CITY OF DUPONT

REPORT AND RECOMMENDATION TO THE DIRECTOR

Project: Northwest Logistics Center II Parking Lot Expansion
Requests: Type I Minor Site Plan Amendment (PLNG 2021-011)
Date of Report: September 3, 2021
From: Lisa Klein, AICP - AHBL, Inc. (Planning Consultant to the City)

SUMMARY OF REQUEST: City approval for Type I Minor Site Plan Amendment (PLNG 2021-011).

1 OVERALL SITE PLAN
1" = 60'-0"

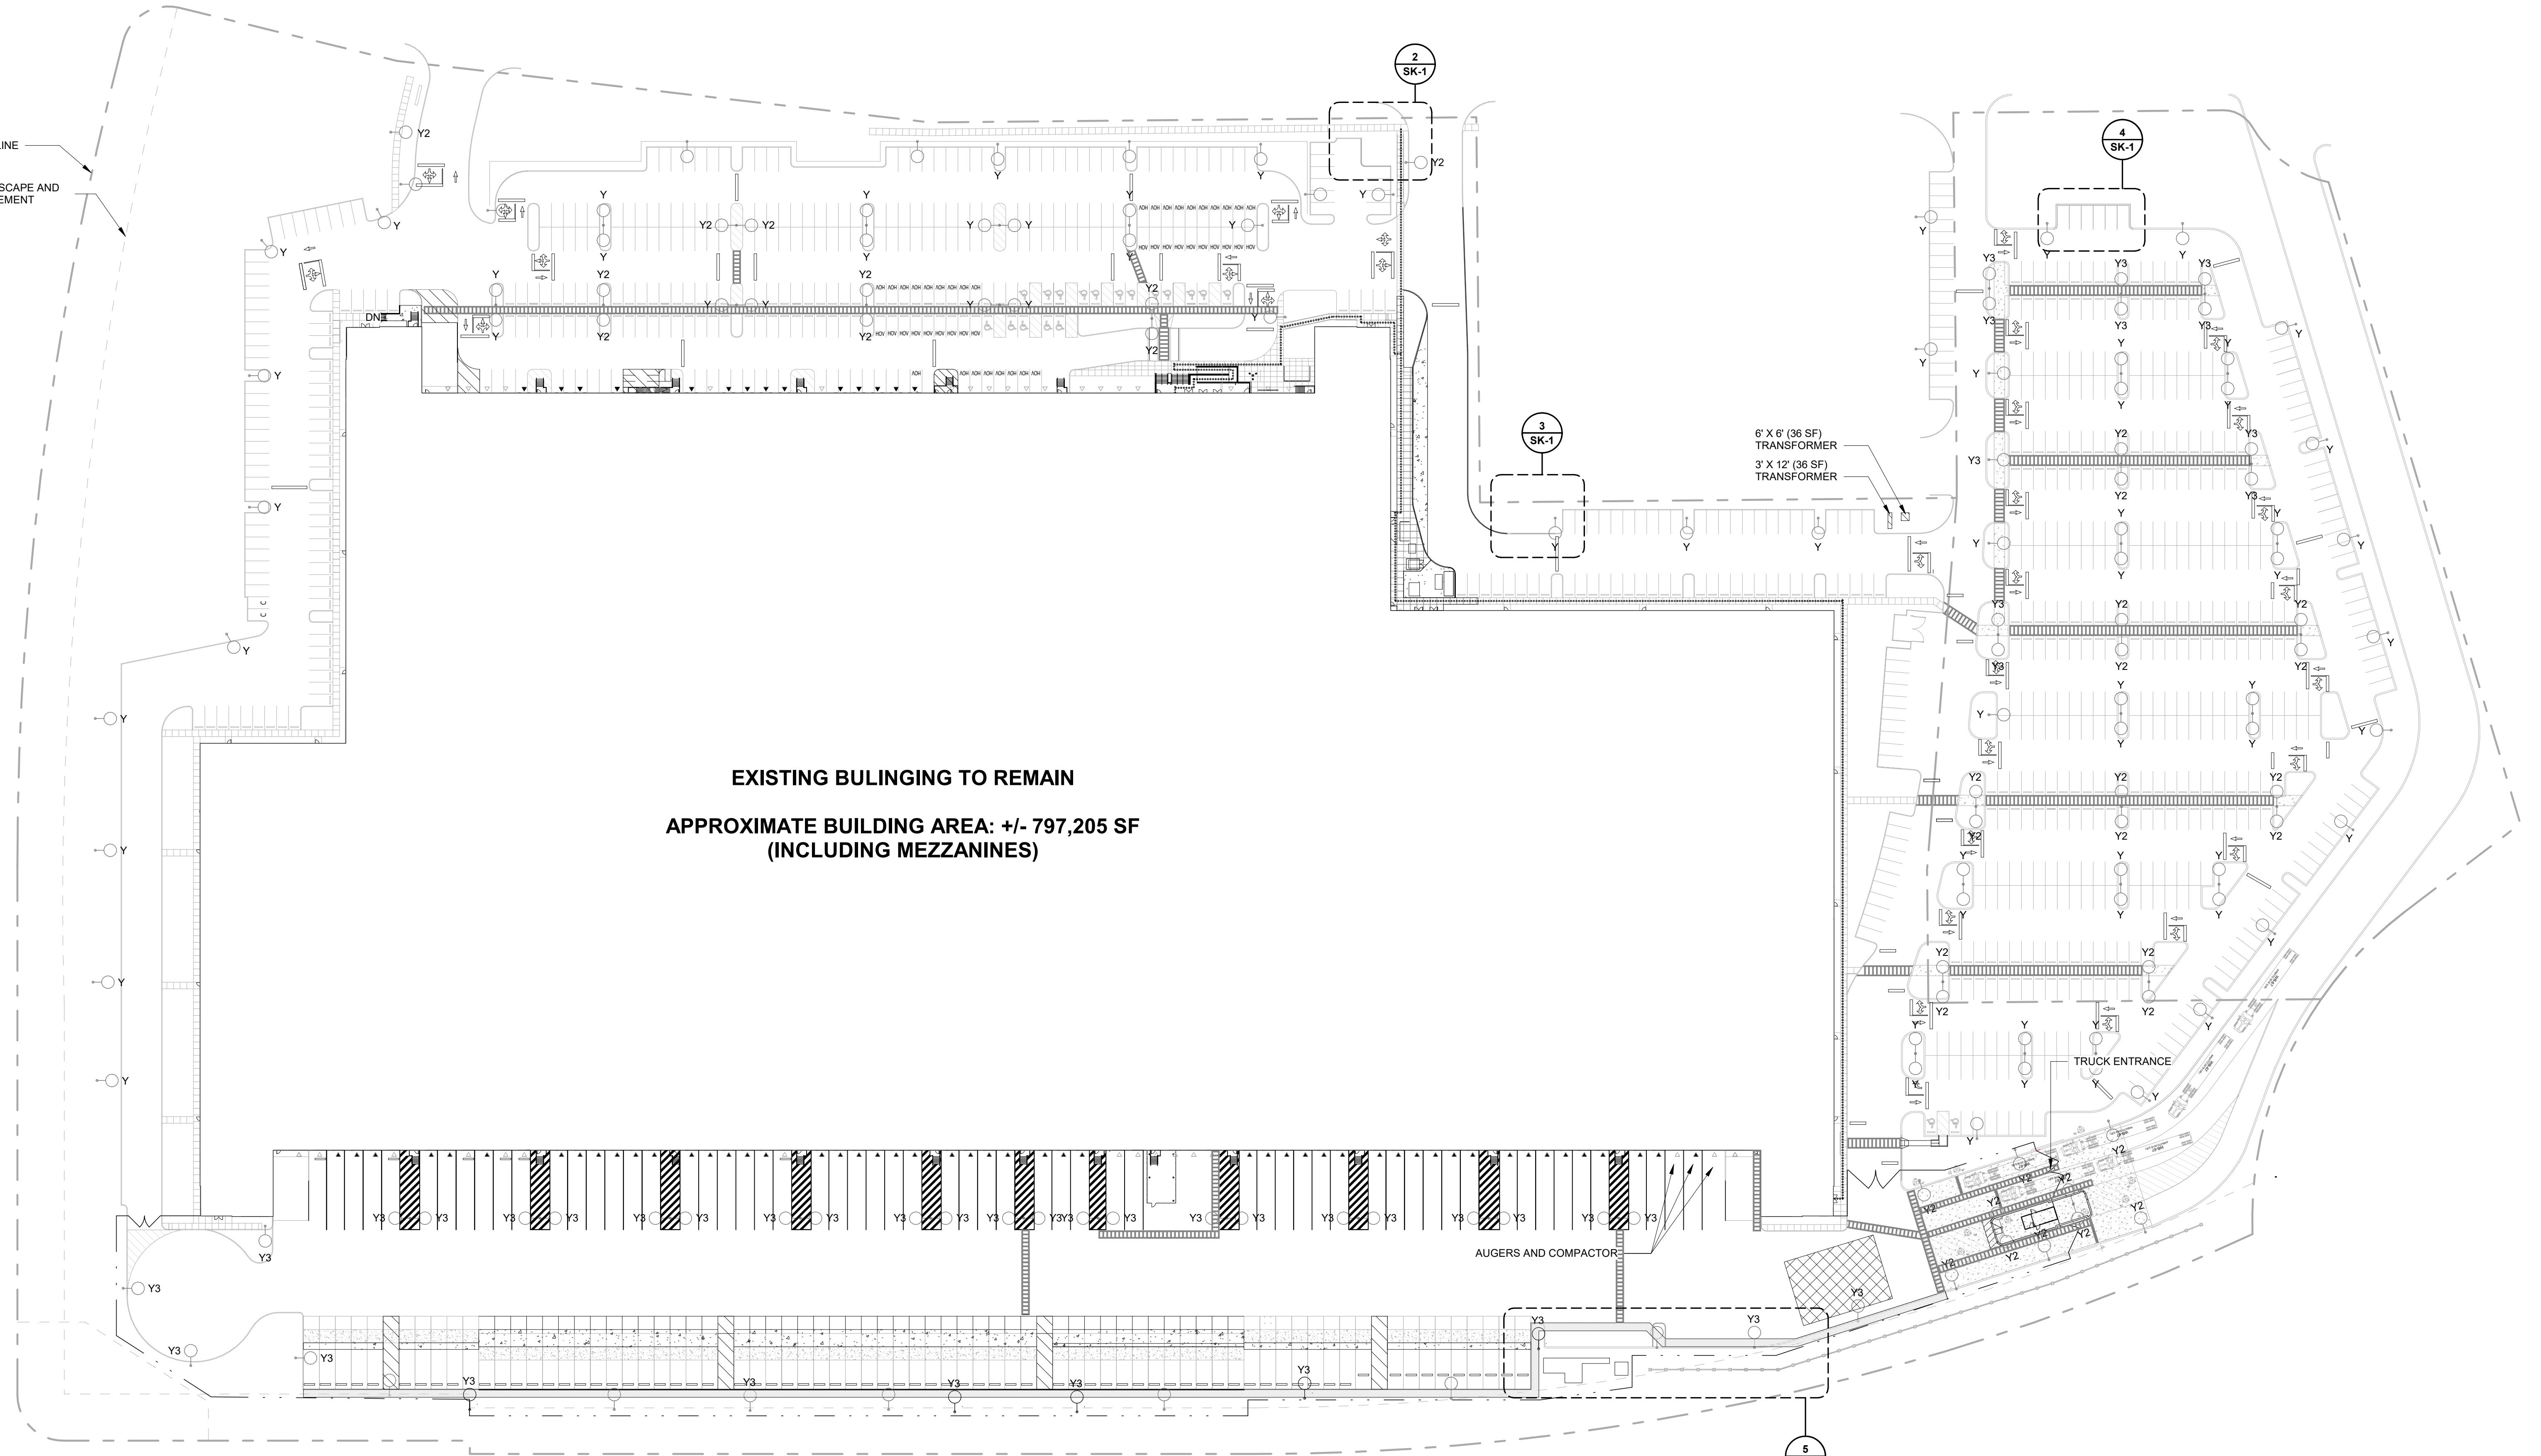
- a. The Minor Site Plan Amendment is required as a result of changes to the site plan caused by the addition of seven additional electrical transformers, as required by the Washington State Department of Labor and Industries, as needed to meet the electric vehicle requirements. Standard vehicle parking spaces have been impacted and replaced with electric vehicle spaces. Landscape areas have been impacted; however, paved areas have been converted to landscaping. There is a reduction of two standard vehicular parking spaces (from 912 to 910 spaces) and there is a 1 SF addition to landscape area for the site. A total of 19.4 percent of the site will be landscape area (317,343 SF).

Staff Analysis and Conclusions: The proposal received approval of a variance to reduce the landscape area to 19.4 percent across the overall 37.5-acre property (PLNG2020-013). The proposed minor site plan amendment will increase the landscape area by 1 SF, which still provides 19.4 percent landscape area (317,343 SF). The proposal exceeds landscape area from the original approval and is therefore compliant.

Staff Analysis and Conclusions: The project proposes a total of 910 parking spaces, which will require a total of 152 trees in the parking lot areas. The previously approved Landscape Plan proposed to plant 154 new trees, plus the 27 existing trees, for a total of 181 trees within the parking areas. The modifications convert paved area to new landscaping and do not reduce the quantities of trees to be planted. The proposal is compliant.

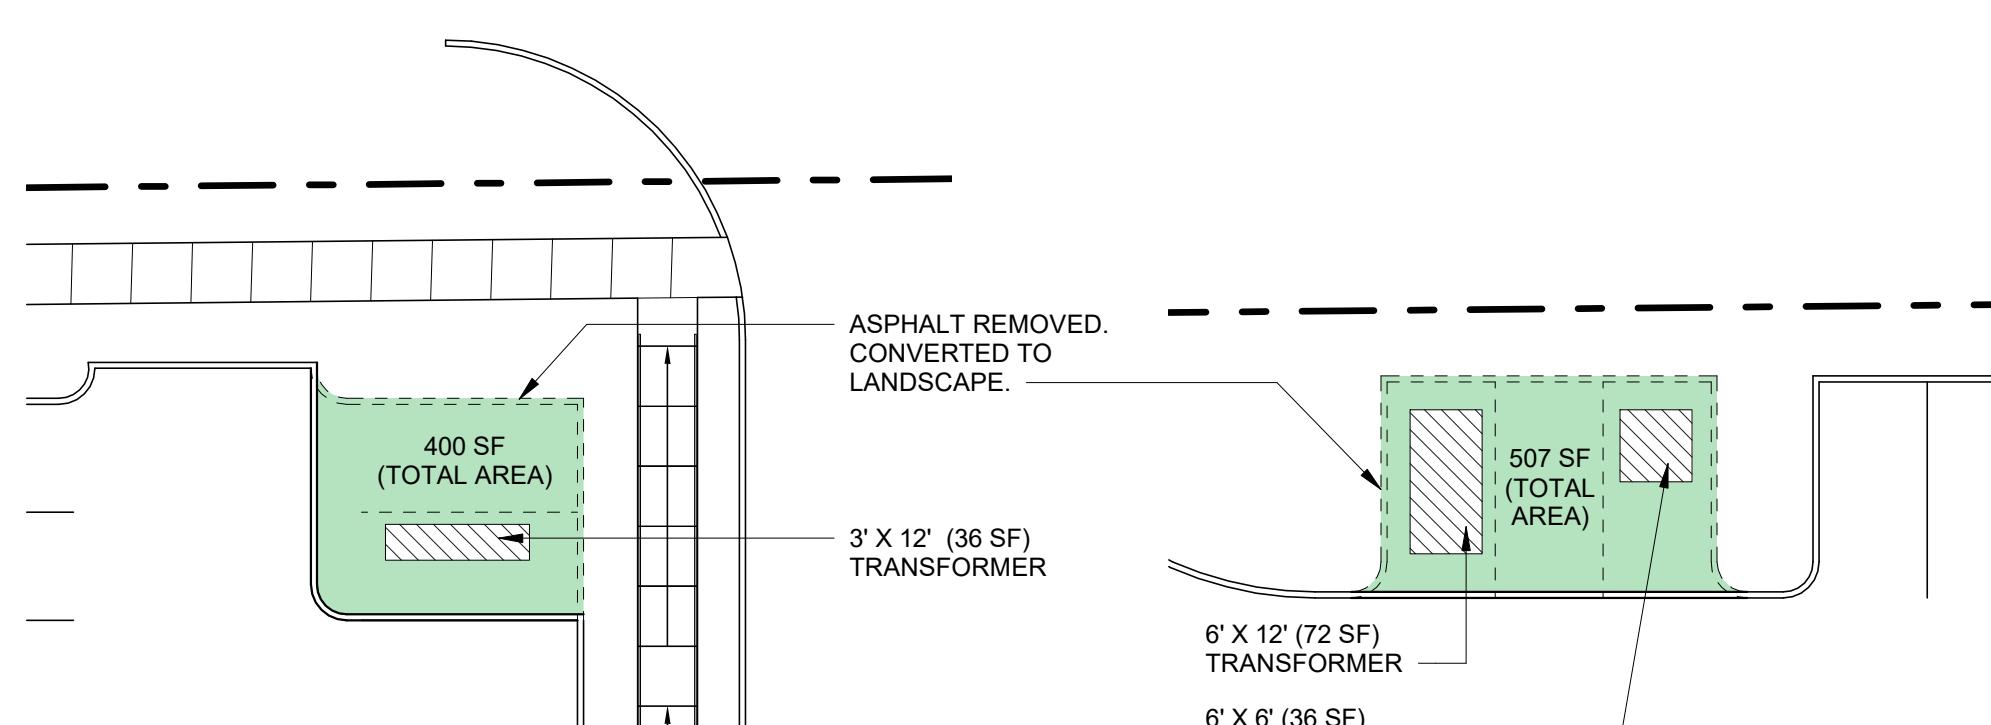
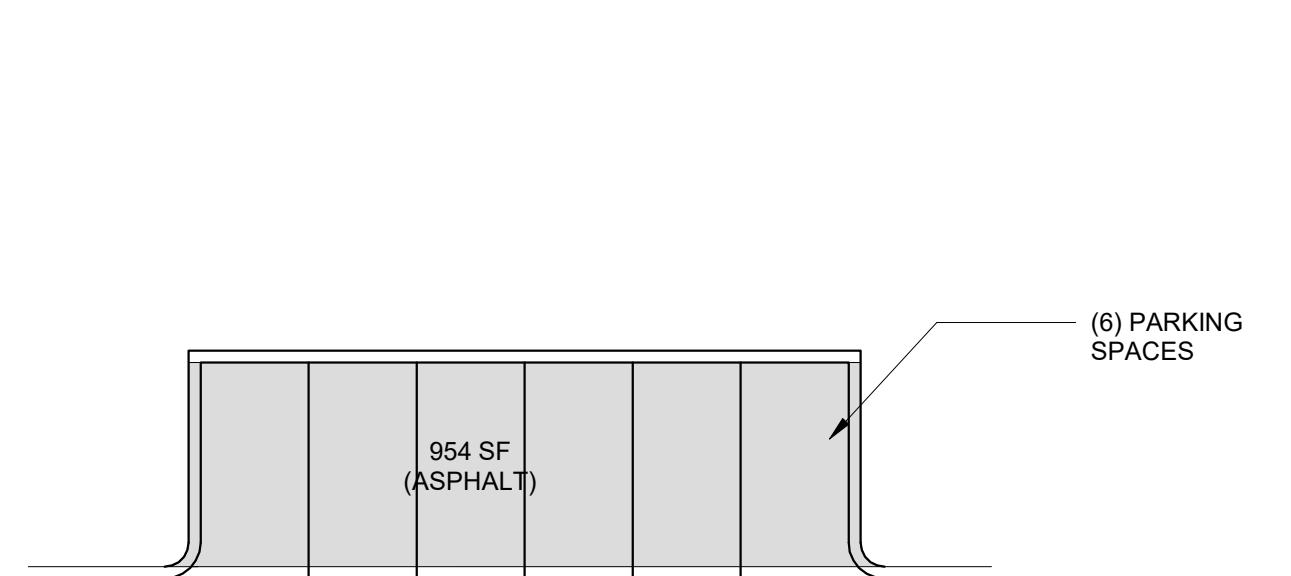
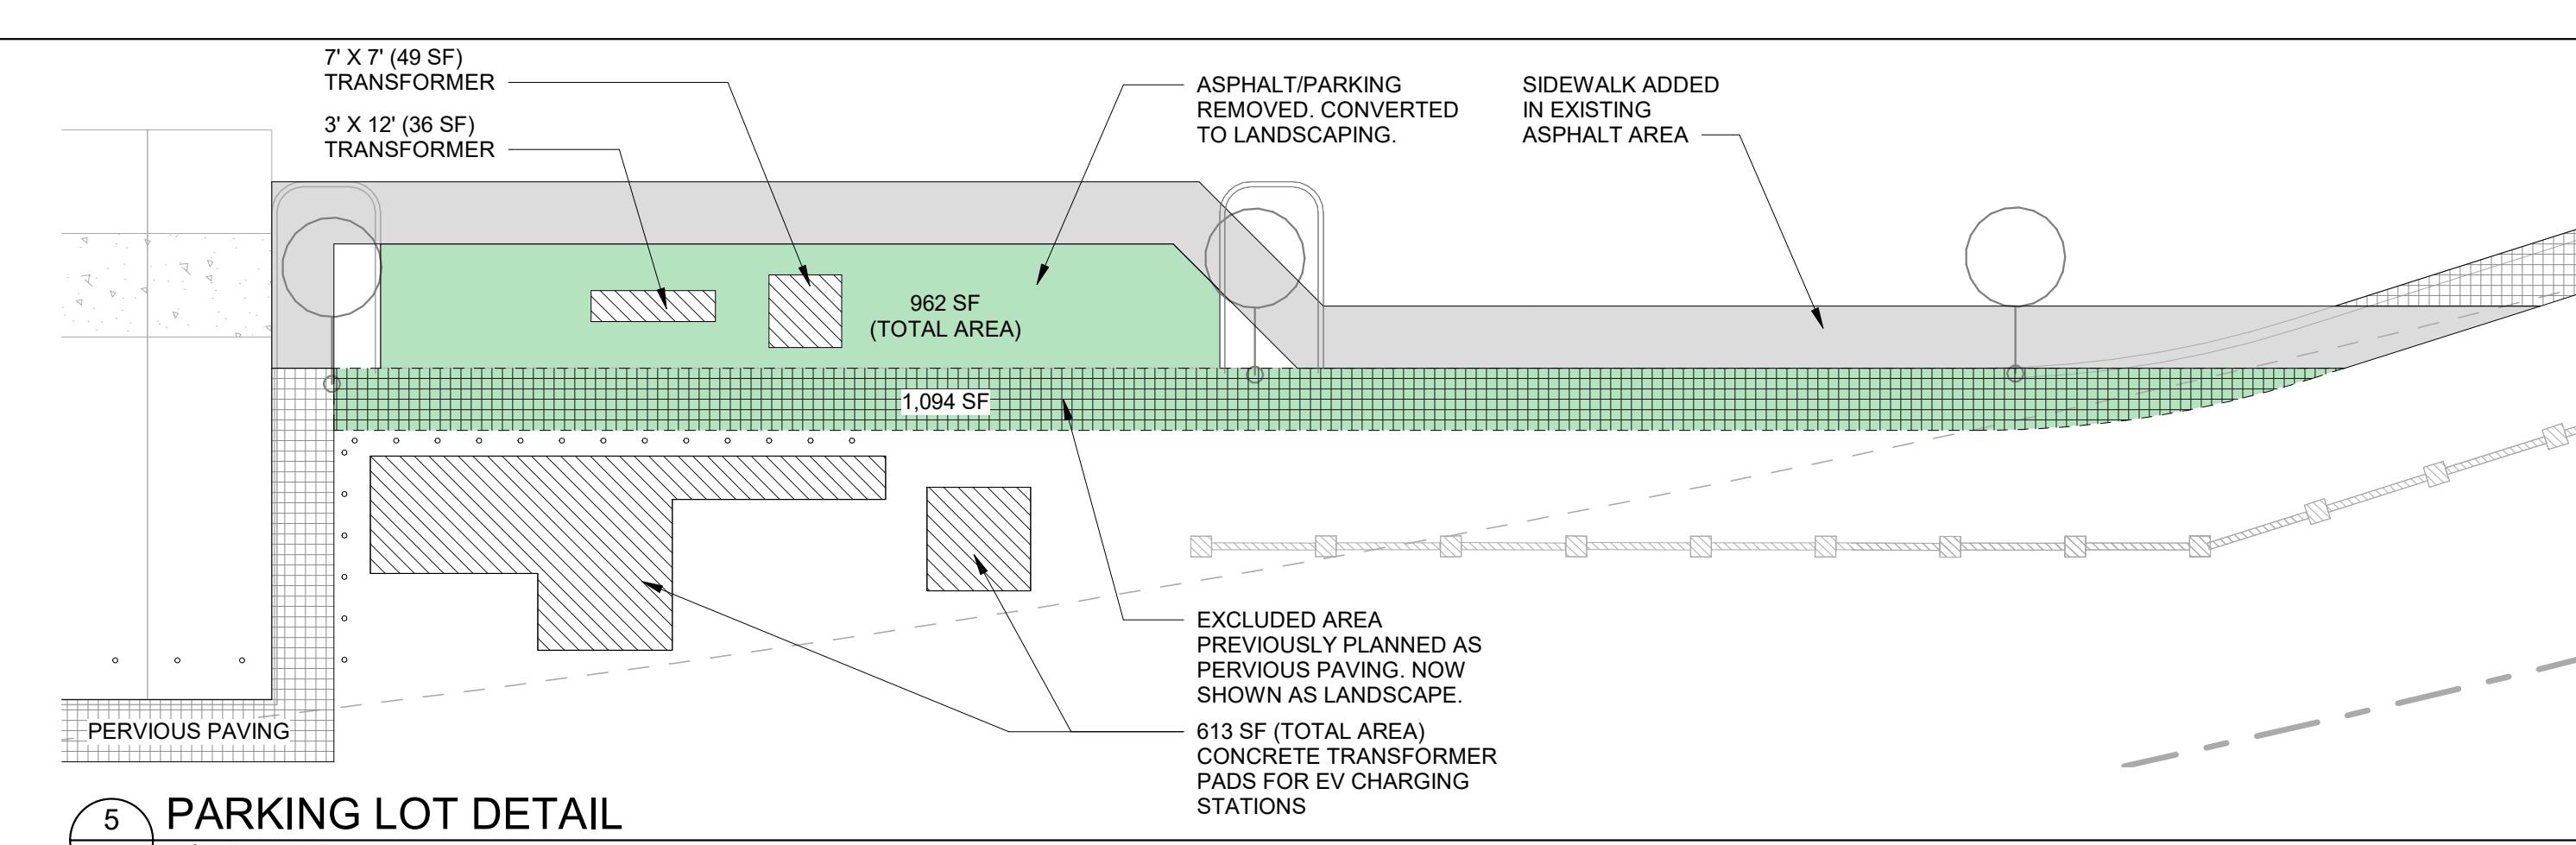
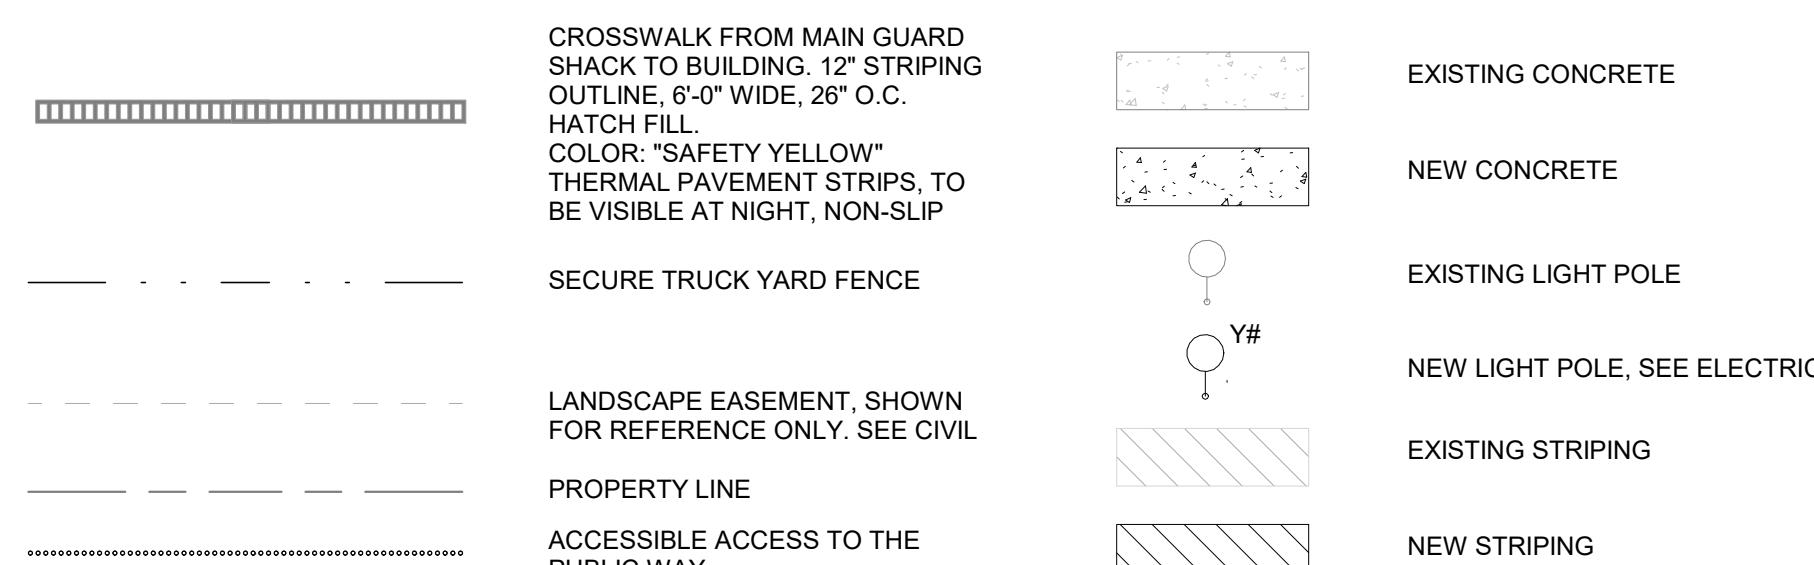
Removed (SF)	Added (SF)	Net (SF)	Notes
Asphalt/Concrete	1,869 SF	1,567 SF	-302 SF	East portion of lot originally constructed as passenger car parking, not usable in the current condition as truck yard. Includes concrete transformer pads for EV charging stations.
Transformer	0 SF	301 SF	+301 SF	Sum of (7) transformer cover involved in revision
			-1 SF	Impervious Total
Landscape	1,567 SF	2,662 SF	+1,095 SF	Includes conversion of pervious walkway to landscape
Pervious Paving	1,094 SF	0 SF	-1,094 SF	Portion of pervious walkway converted to landscape. Concrete walk placed over existing asphalt.
			+1 SF	Pervious Total
Parking	8 stalls	6 stalls	-2 stalls	See site plan for parking totals
